# Errata Sheet

August 8, 2003 / Release 1.6

<b>Device:</b>	<b>SAB-C161PI-LM, -L25M SAF-C161PI-LM, -L25M SAB-C161PI-LM3V SAF-C161PI-LM3V  SAB-C161PI-LF, -L25F SAF-C161PI-LF, -L25F SAB-C161PI-LF3V SAF-C161PI-LF3V</b>
<b>Stepping Code / Marking:</b>	<b>ES-AA, AA ES-BA-H, BA-H</b>
<b>Package:</b>	<b>P-MQFP-100-2, P-TQFP-100-1</b>

#### **Case 4: NO Clock @ XTAL1 and Power-on Detection FAIL**

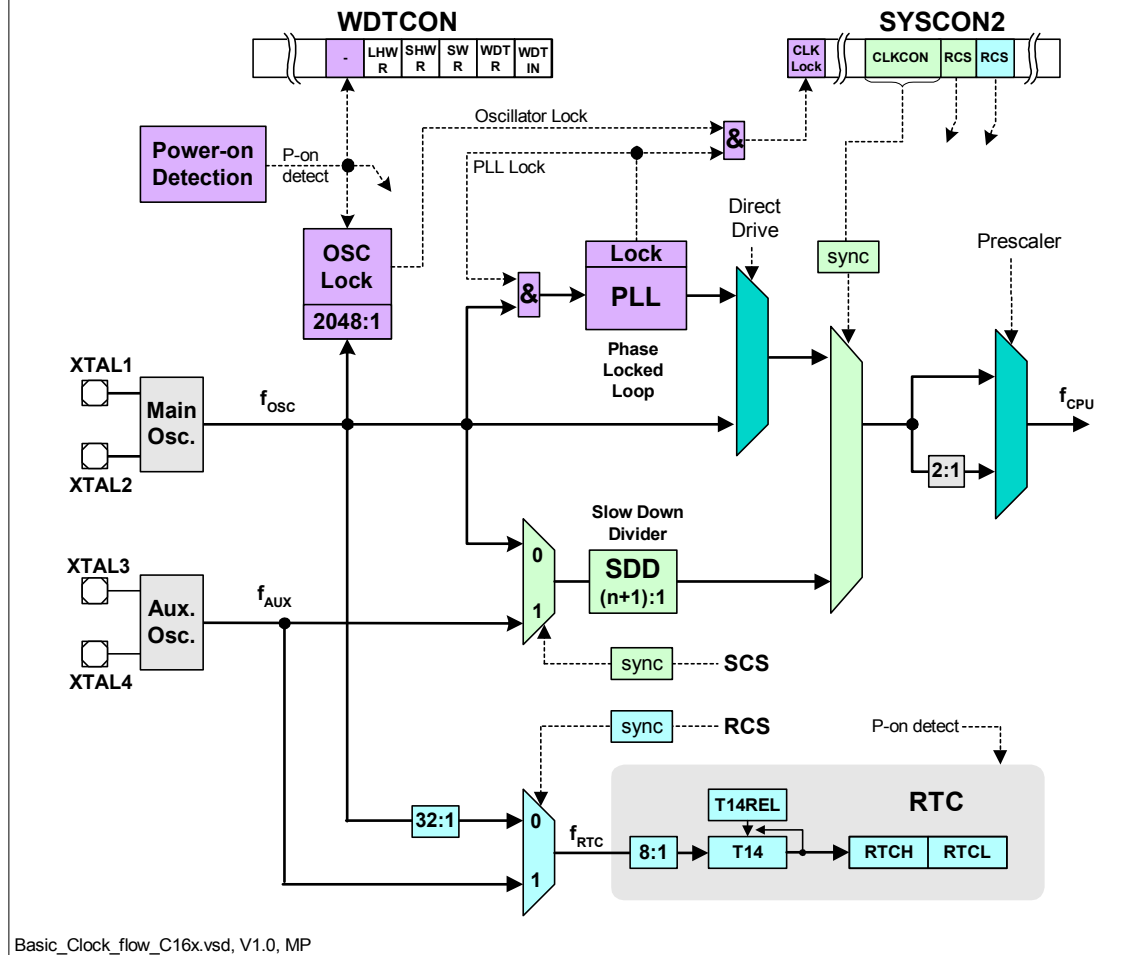
If the system gets no clock at XTAL1 during power-on and the power-on detection fails then the following settings can be found:

- The real time clock registers are undefined (T14, T14REL, RTCH, RTCL).
- The slow down divider (SDD) may be selected as  $f_{CPU}$  clock source (no oscillator watchdog function possible). In that case the system will stop.

Consider the conditions to get a defined clock configuration at power-on.

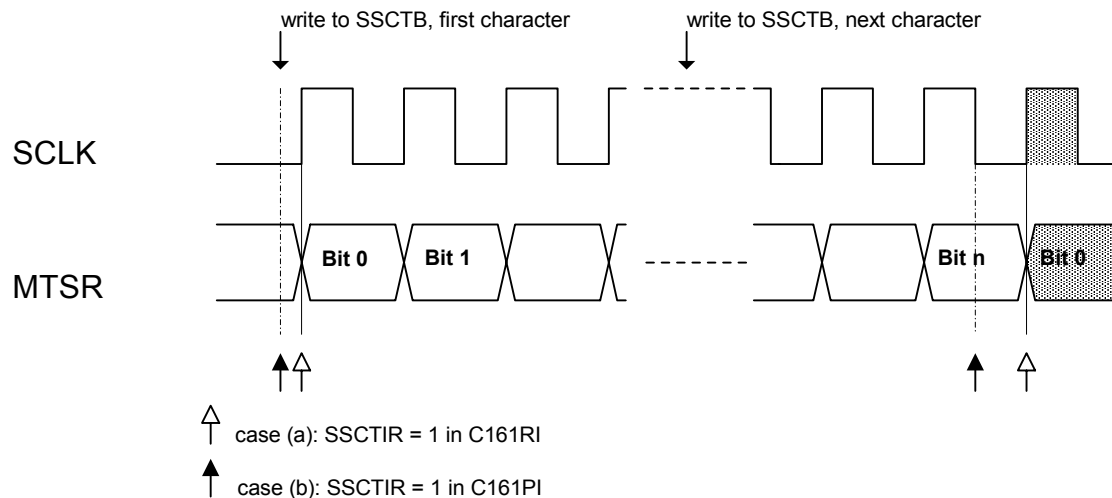
- in the **C161RI**, flag SSCTIR is set to '1' synchronous to the shift clock SCLK 1/2 bit time before the first latching edge (= first shifting clock edge when SSCPH = 0). When SSCTB is written while the shift register is empty, the maximum delay between the time SSCTB has been written and flag SSCTIR=1 is up to 1/2 bit time.
- in the **C161PI**, when SSCTB has been written while the transmit shift register was empty (and the SSC is enabled), flag SSCTIR is set to '1' directly after completion of the write operation, independent of the selected baud rate. When the transmit shift register is not empty when SSCTB was written, SSCTIR is set to '1' after the last latching edge of SCLK (= 1/2 bit time before the first shifting edge of the next character). See also e.g. C167CR User's Manual V3.1, p. 12-5.

The following diagram shows these relations in an example for a data transfer in master mode with SSCPO = 0 and SSCPH = 0. It is assumed that the transmit shift register is empty at the time the first character is written to SSCTB:

Typically, in interrupt driven systems, no problems are expected from the modified timing of flag SSCTIR. However, when flag SSCTIR is polled by software in combination with other flags which are set/cleared at the end or at the beginning of a transfer (e.g. SSCBSY), the modified timing may have an effect.

Another situation where a different system behaviour may be noticed is the case when only one character is transferred by the PEC into the transmit buffer register SSCTB. In this case, 2 interrupt requests from SSCTIR are expected: the 'PEC COUNT = 0' interrupt, and the 'SSCTB empty' interrupt.
